DEATHERAGE ADDITION

WICHITA, SEDGWICK COUNTY, KANSAS

RE: S/D 98-117-- One-Step Final Plat of DEATHERAGE ADDITION

STAFF REPORT
(One-Step Final Plat Approved 12/10/98)

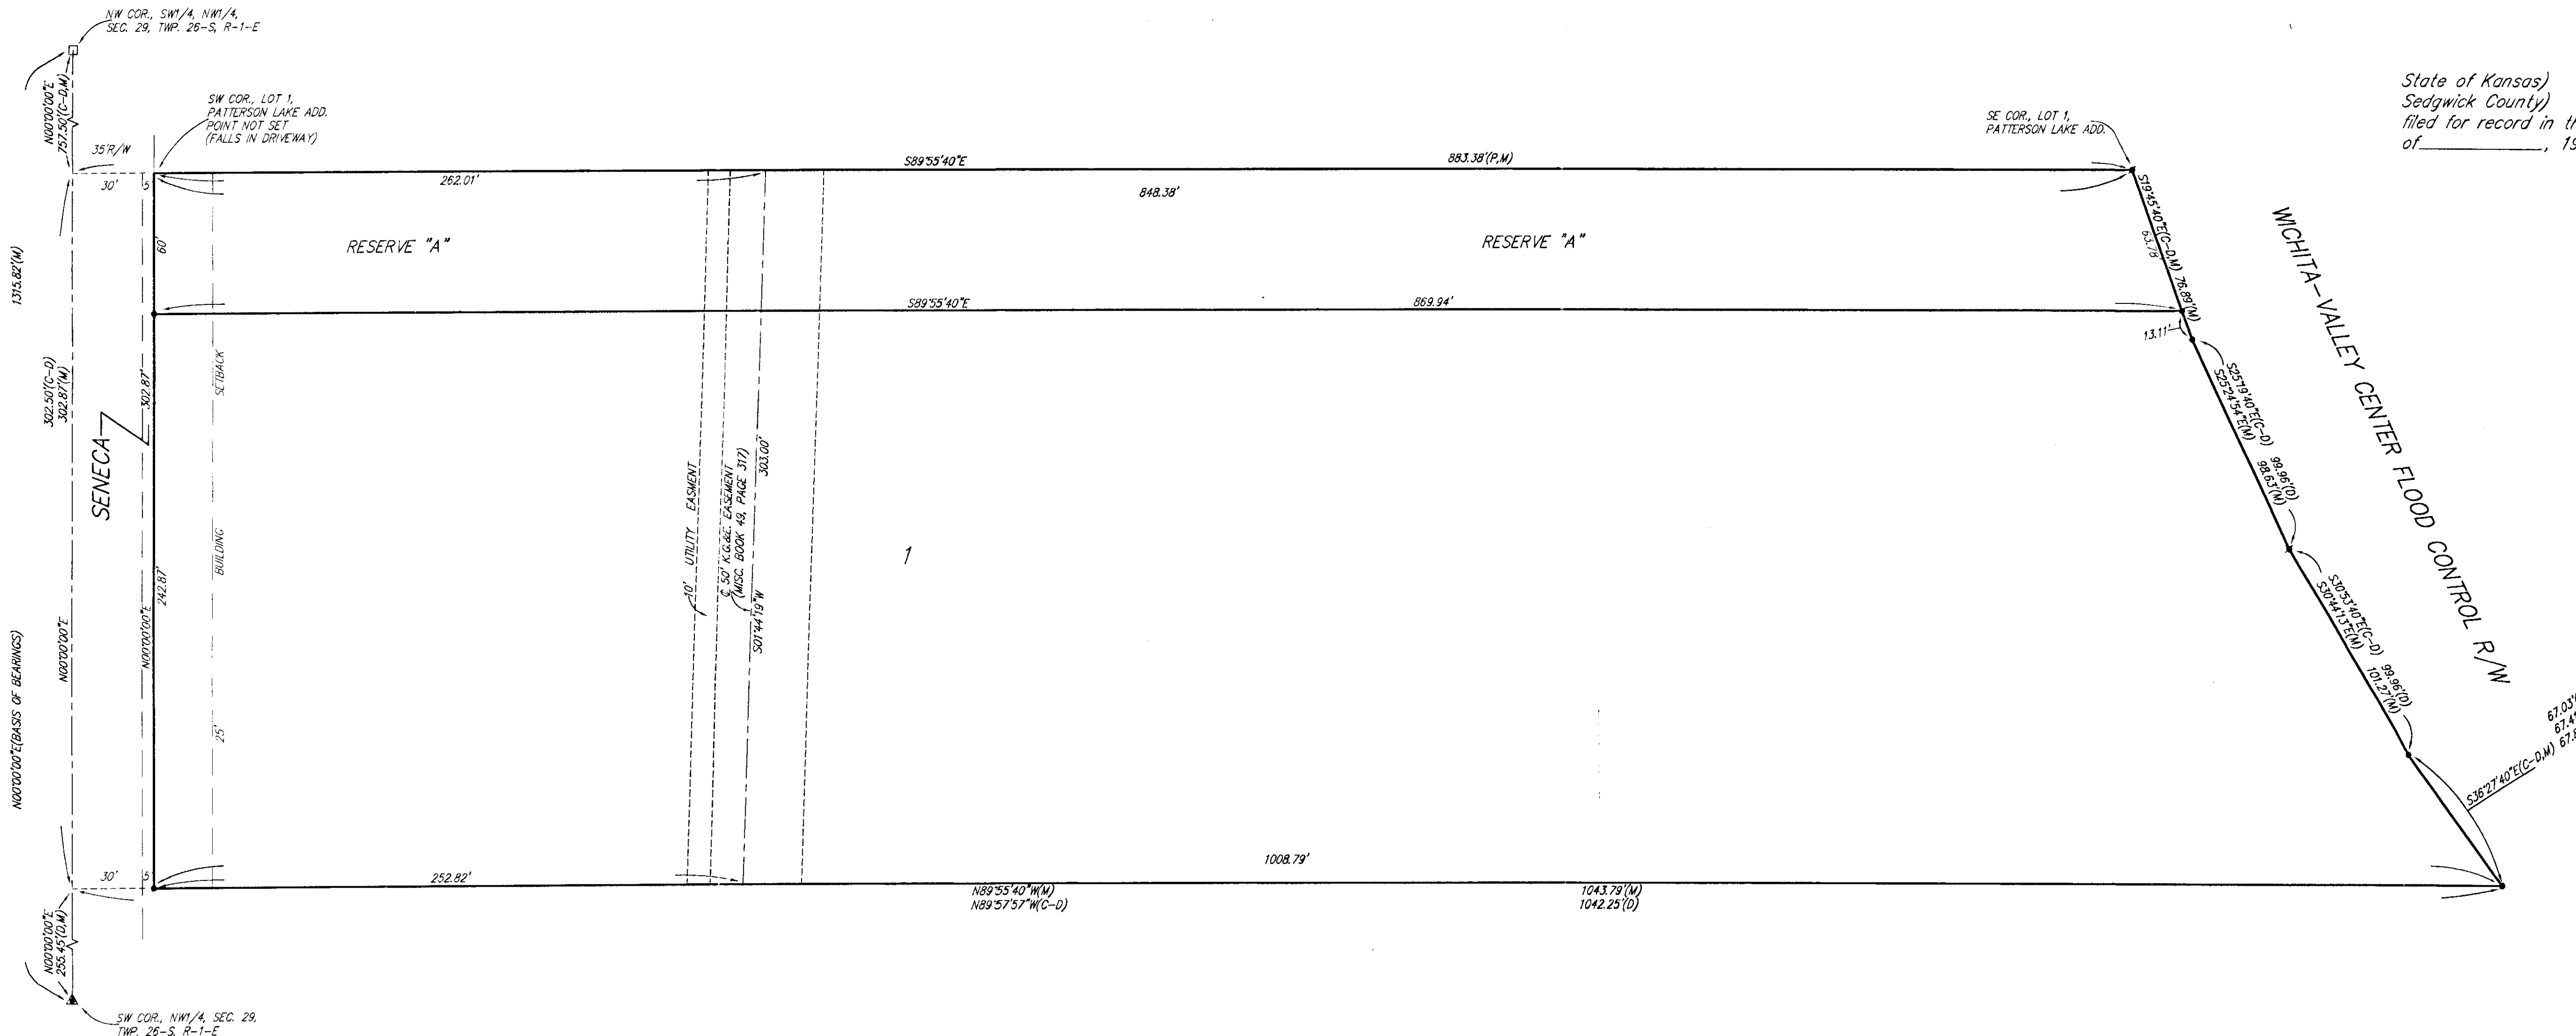
- D. City Engineering needs to comment on the status of the applicant's drainage plan. *The drainage plan is approved. The minimum pad elevation needs to be revised.*

- F. The distances and degrees on the drawing need to coincide with those in the legal description.
- G. The lot depth-to-width ratio exceeds the maximum of 2.5, and a modification will need to be granted for the approval of this plat.

- H. The site is located within the 100-year floodplain and the standard floodway language needs to be added to the plat's text.**
- I. For those reserves being platted for drainage purposes, the required covenant which provides for ownership and maintenance of the reserves shall grant, to the City, the authority to maintain the drainage reserves in the event the owner(s) fail to do so. The covenant shall provide for the cost of such maintenance to be charged back to the owner(s) by a method similar to special assessments.

- J. The MAPC Chairman should be revised to read, "William M. Johnson".
- K. The applicant is reminded that a platting binder is required with the final plat. Approval of this plat will be subject to submittal of this binder and any relevant conditions found by such a review.
